MODIFICATION INSTRUCTIONS

EFFECT: X-Y TIMING BOARD

ENGINEERING CHANGE NOTICE

ECN # 978

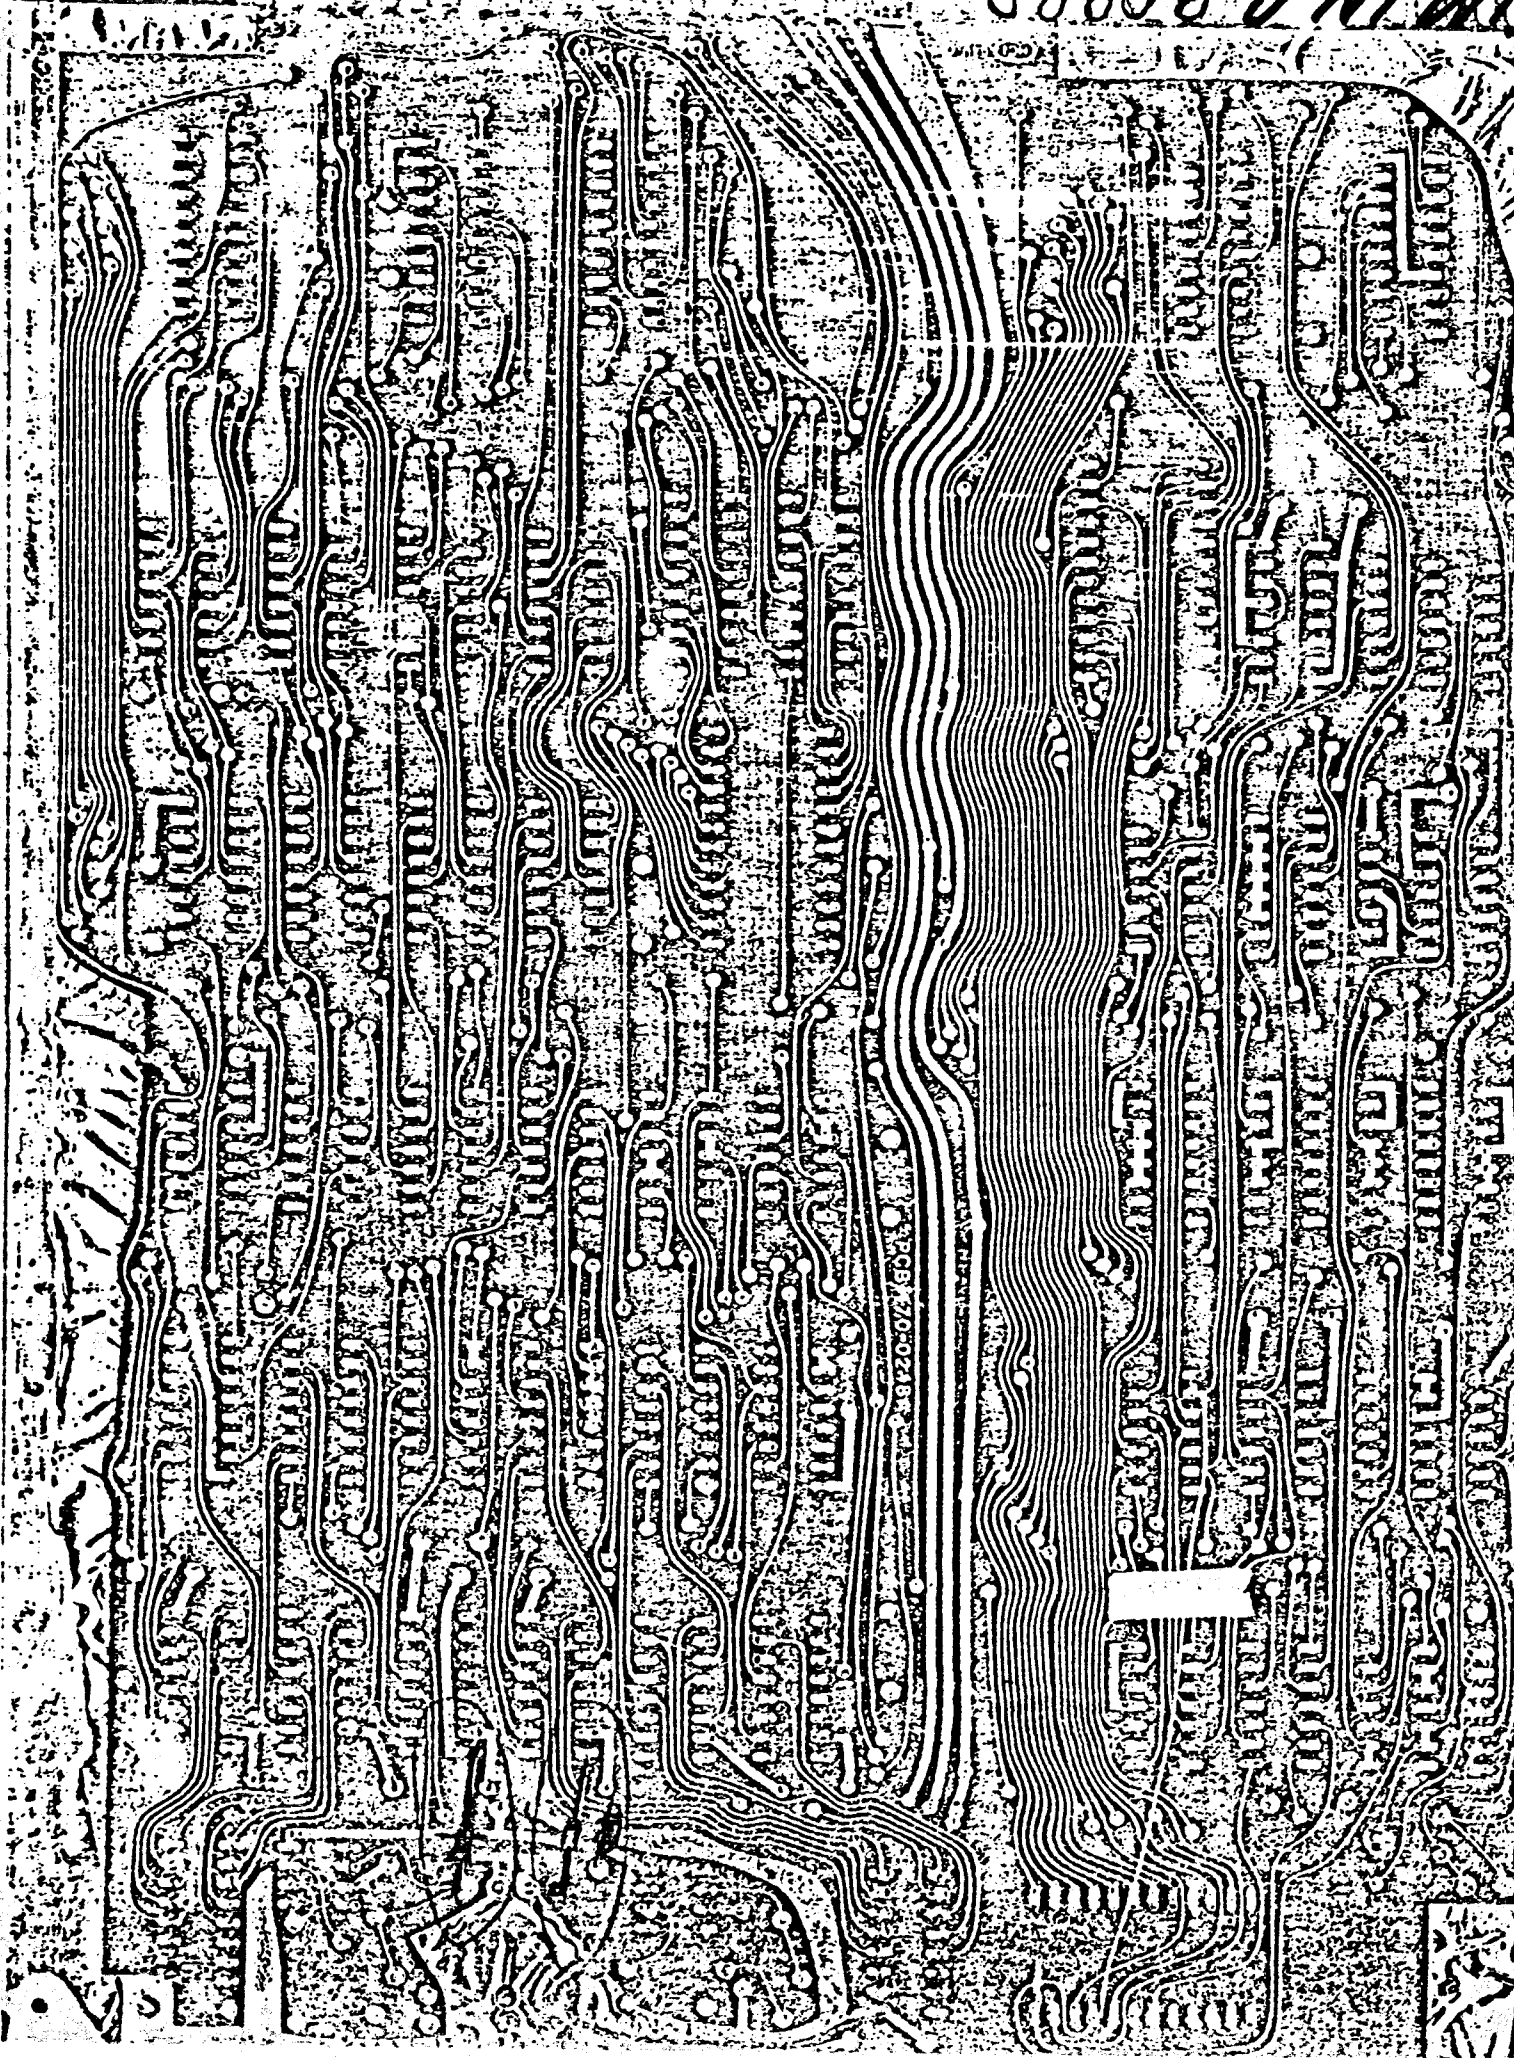
CHANGE: PARTS LIST:

<u>ITEM</u>	<u>P/N</u>	<u>QTY</u>	<u>WAS</u>	<u>REF DES</u>
1	150-0088	153	WAS 4	15 C43C46.C62 WAS C43.C45.C46.C62

ADD ITEM 58:

P/N 151-0031 QTY (1) CAP CER .22UF 16V C45

CHANGE SHEET 6 ZONE 7A:

REDUCE POWER ON DELAY FROM 1.5 SECS TO 20 MSECS TO ALLOW XV MONITOR OUTPUTS TO BE RESET IN 20 MSECS THEREBY REDUCING STRESS ON MONITOR OUTPUT CIRCUITS

PCB 70-01288

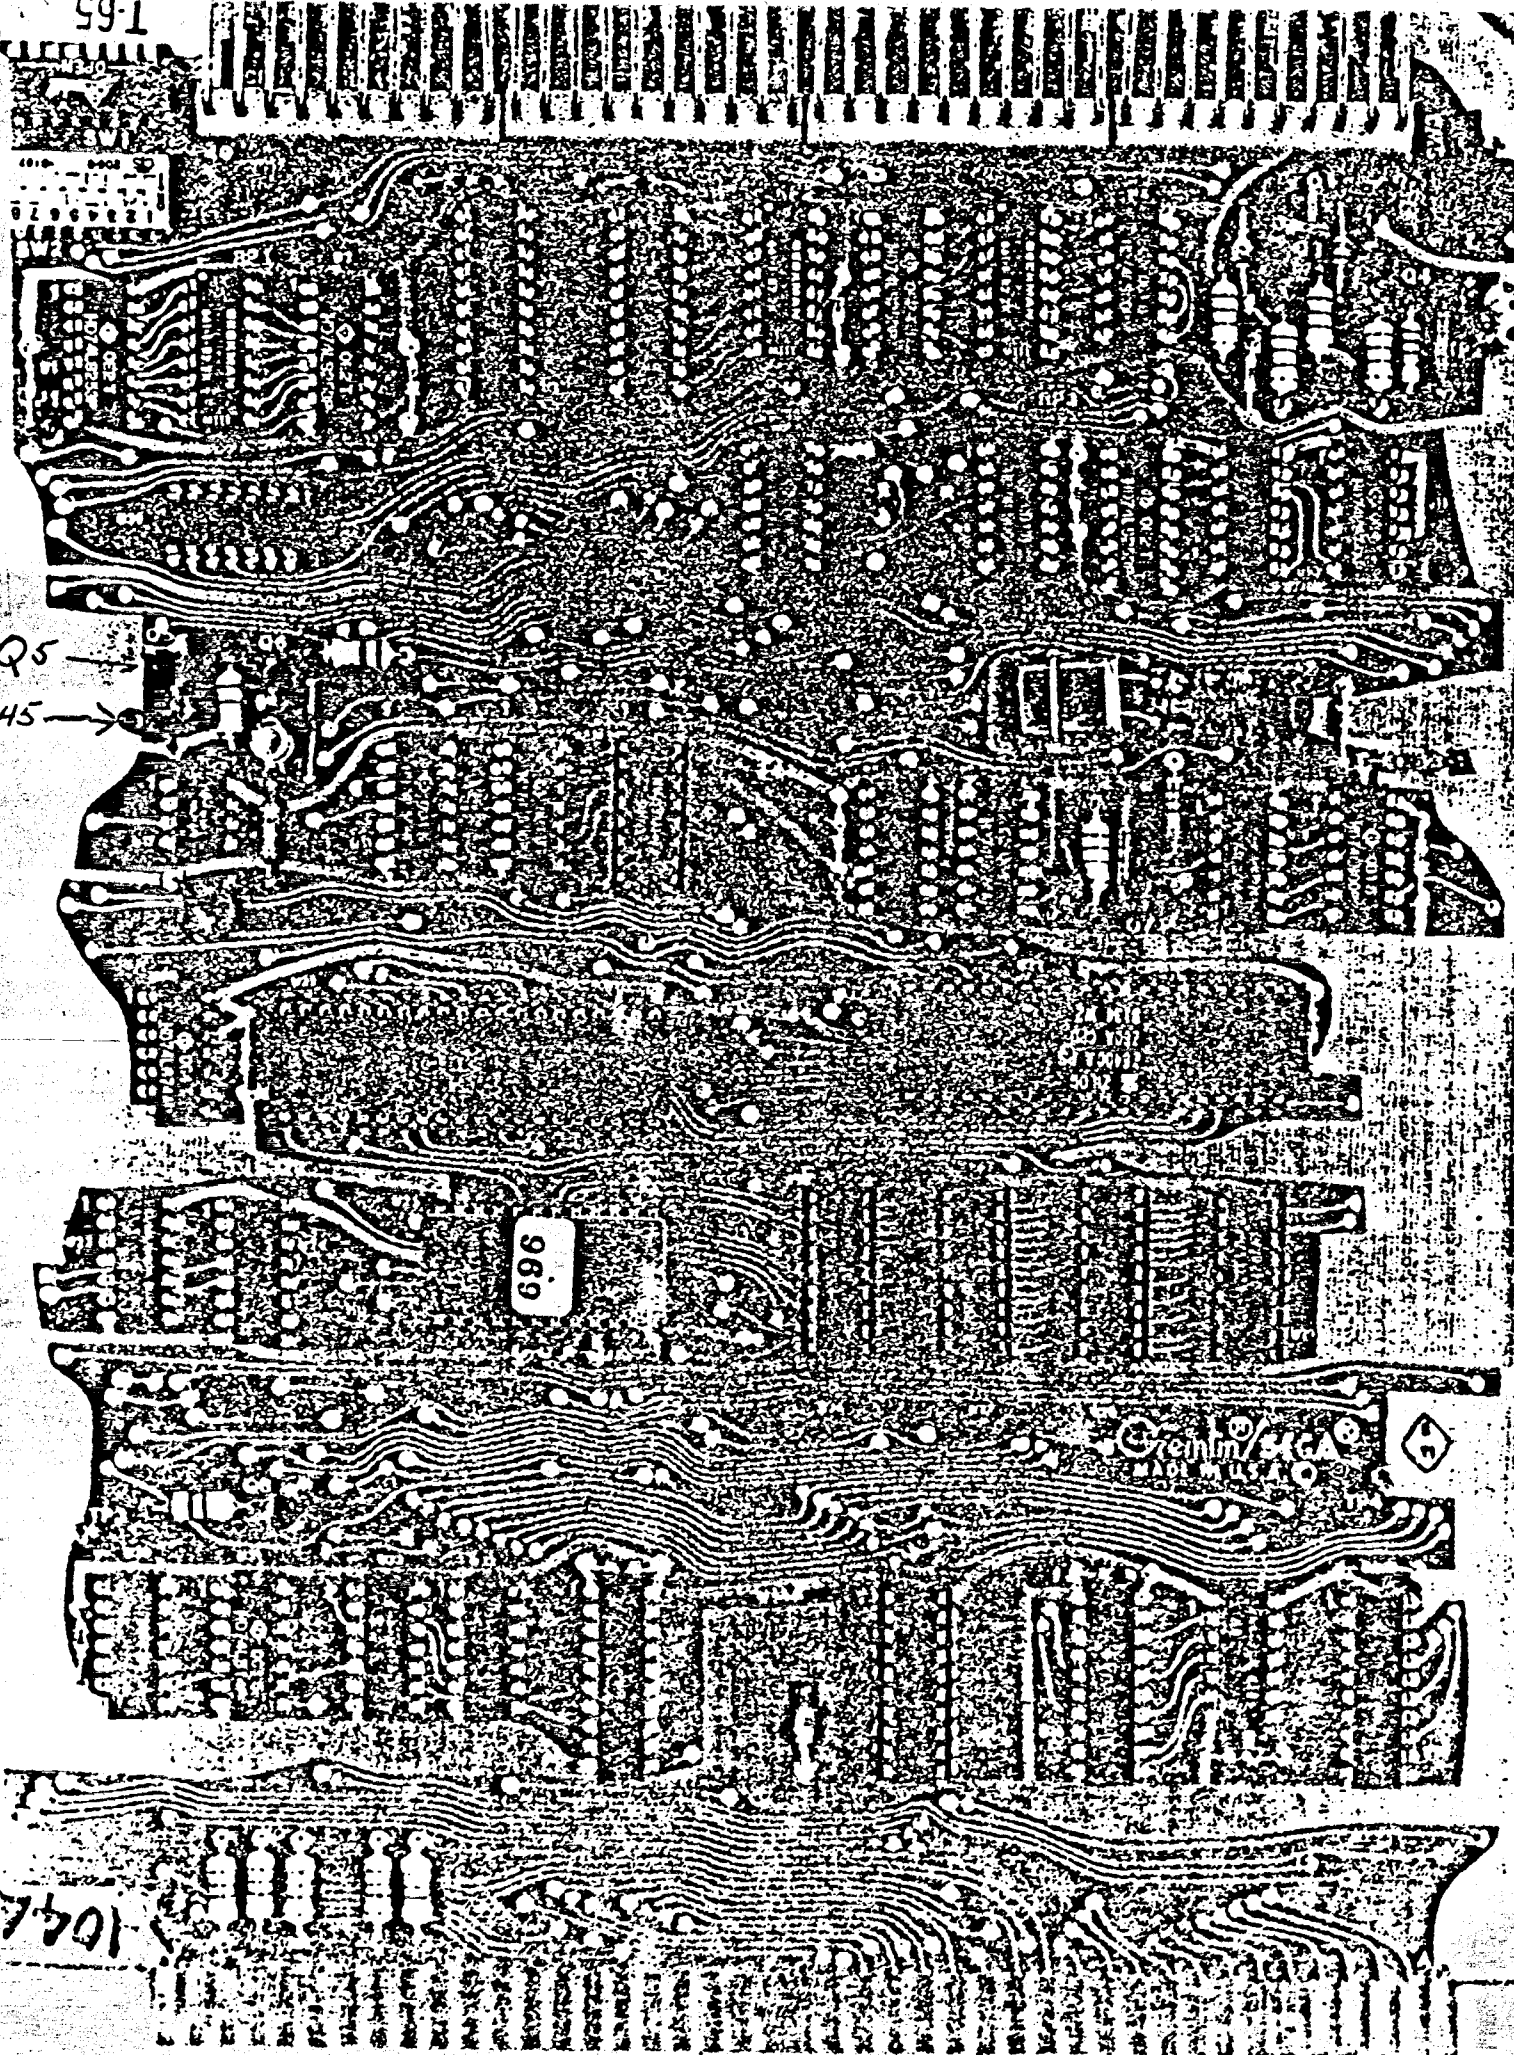
Q5 →
C45 →

SUBSTITUTE MATERIAL USE GREMLIN P/N 152-0029 .33UF 250V
CERAMIC CAPACITORS TO REPLACE 151-0031 ON C45 OF
